ADDENDUM NO. 4

February 10, 2023

SOLON ROBINSON ELEMENTARY SCHOOL ADDITIONS, RENOVATIONS, AND RELATED WORK Crown Point, IN 46307

EP105

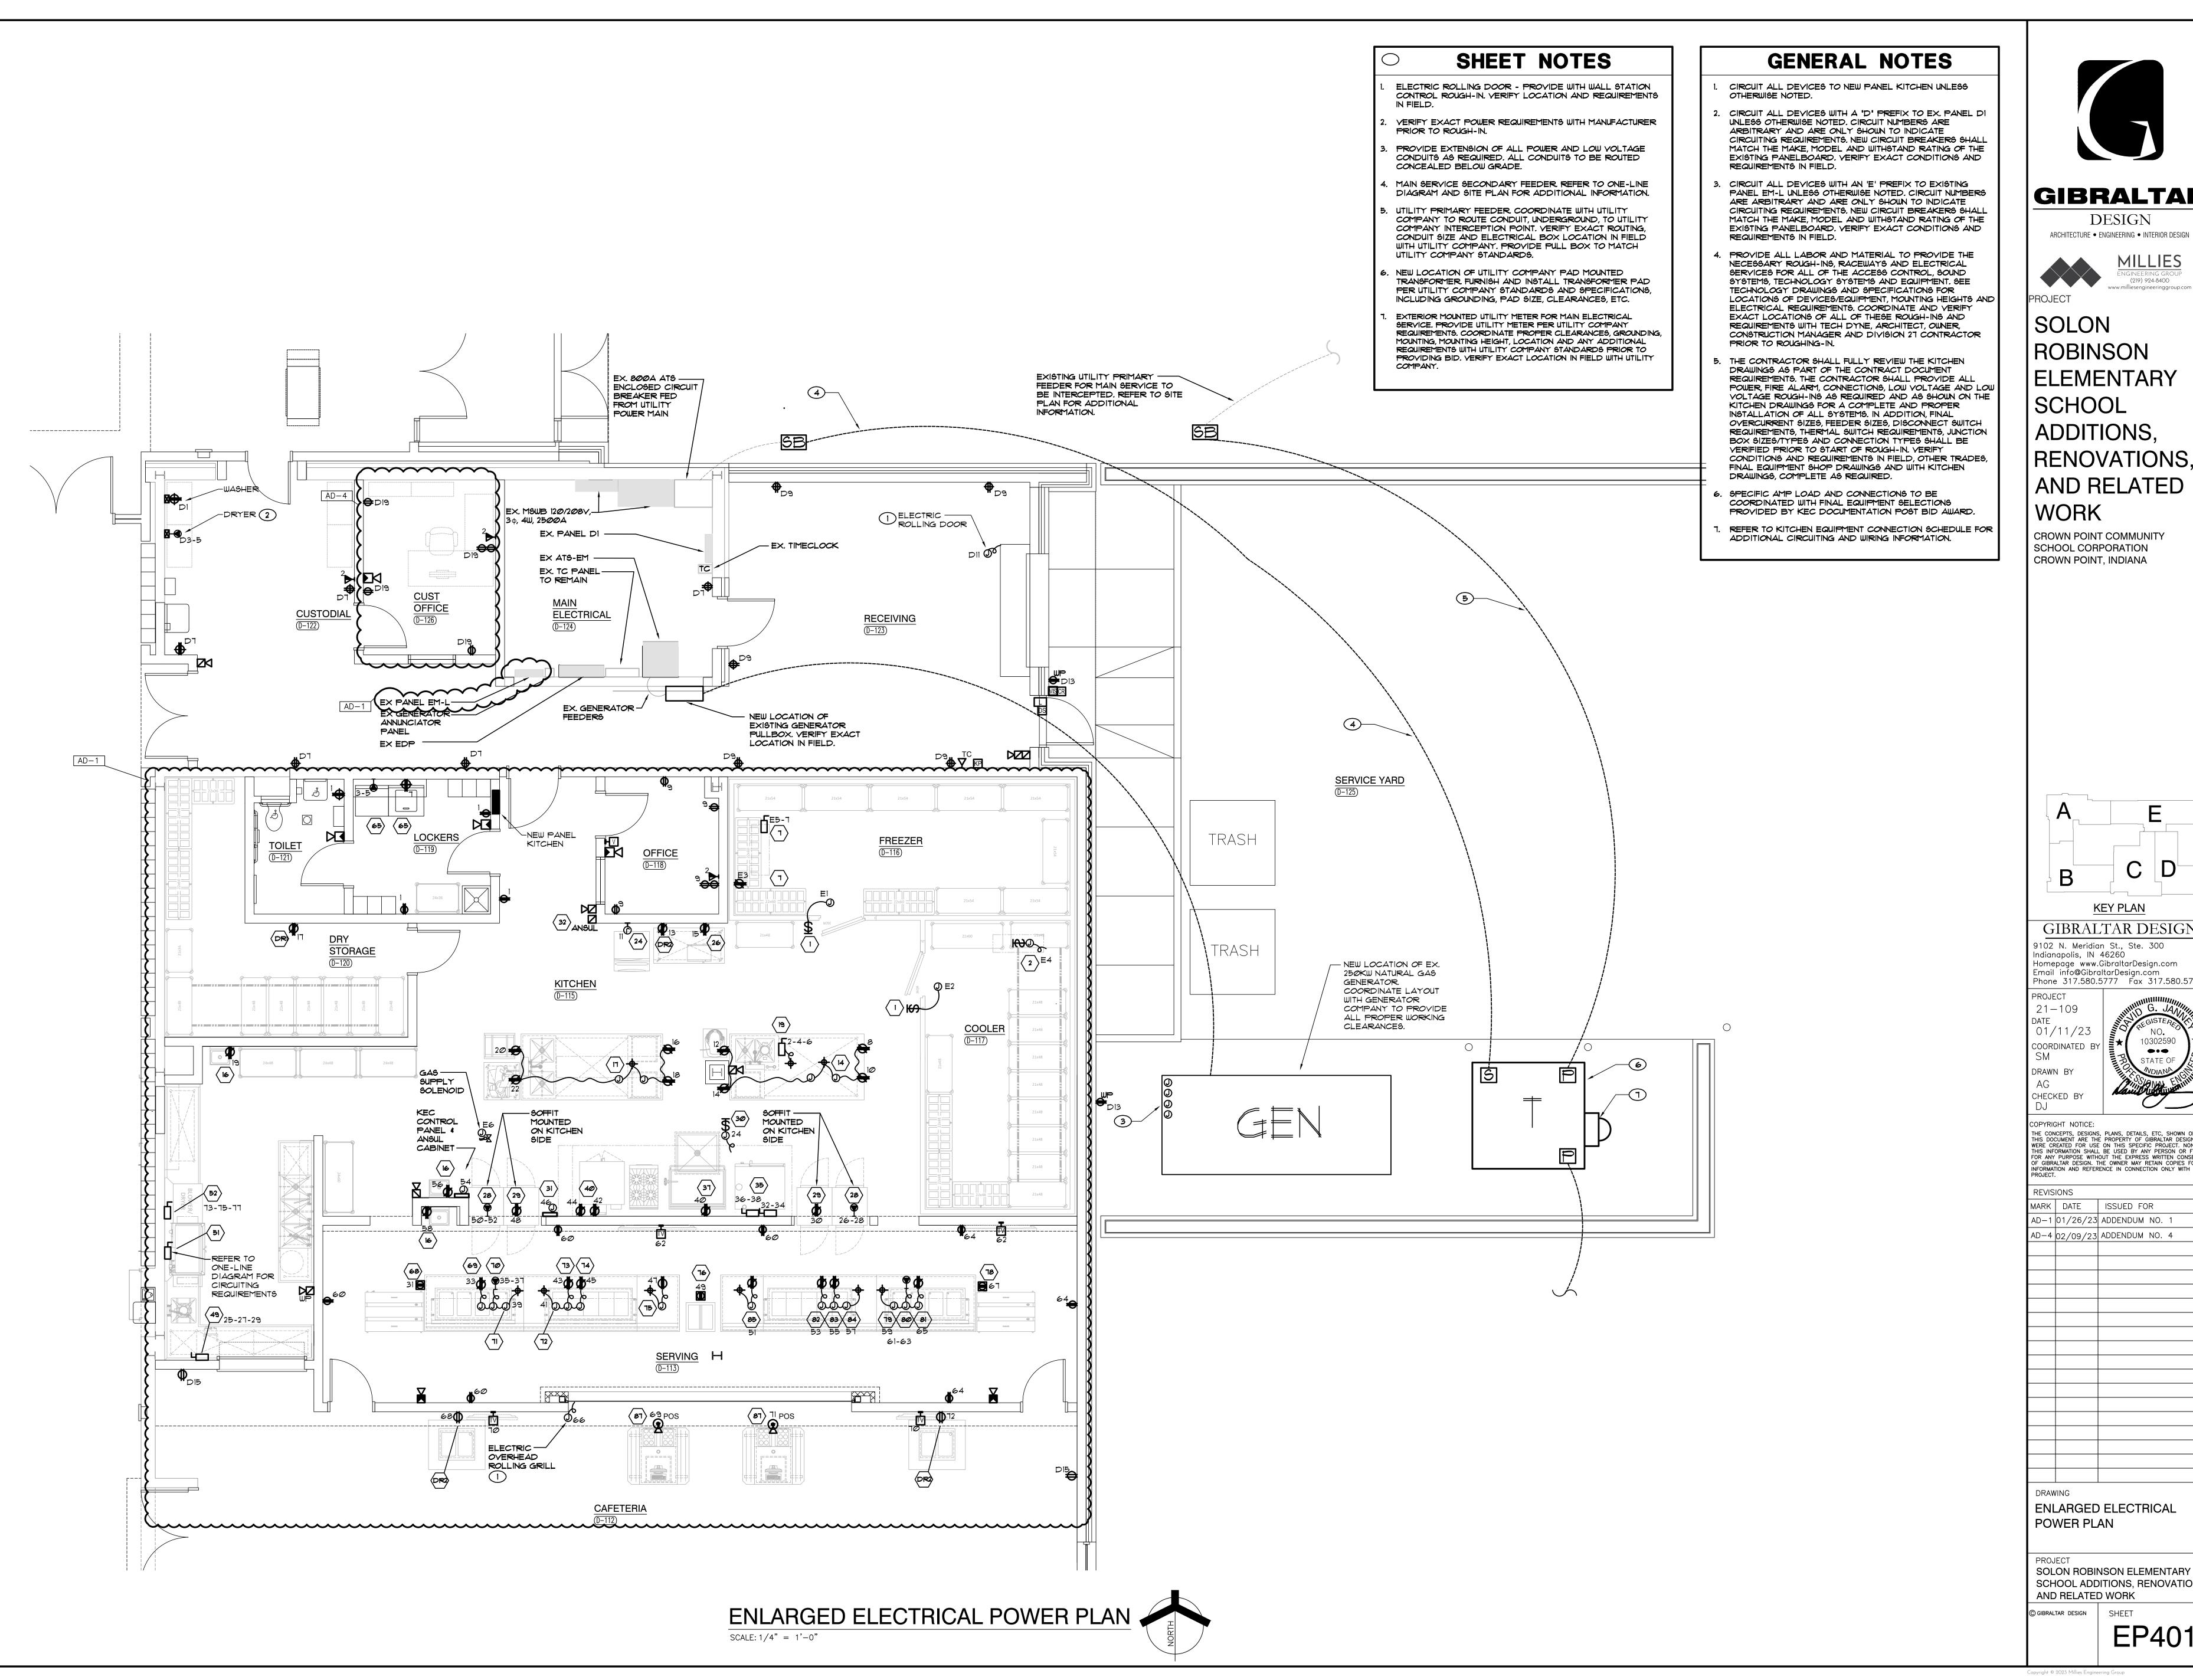
43. Sheet EP102, EP104, EP105

- A. Add sheet note.
- B. Add door hardware circuitry.
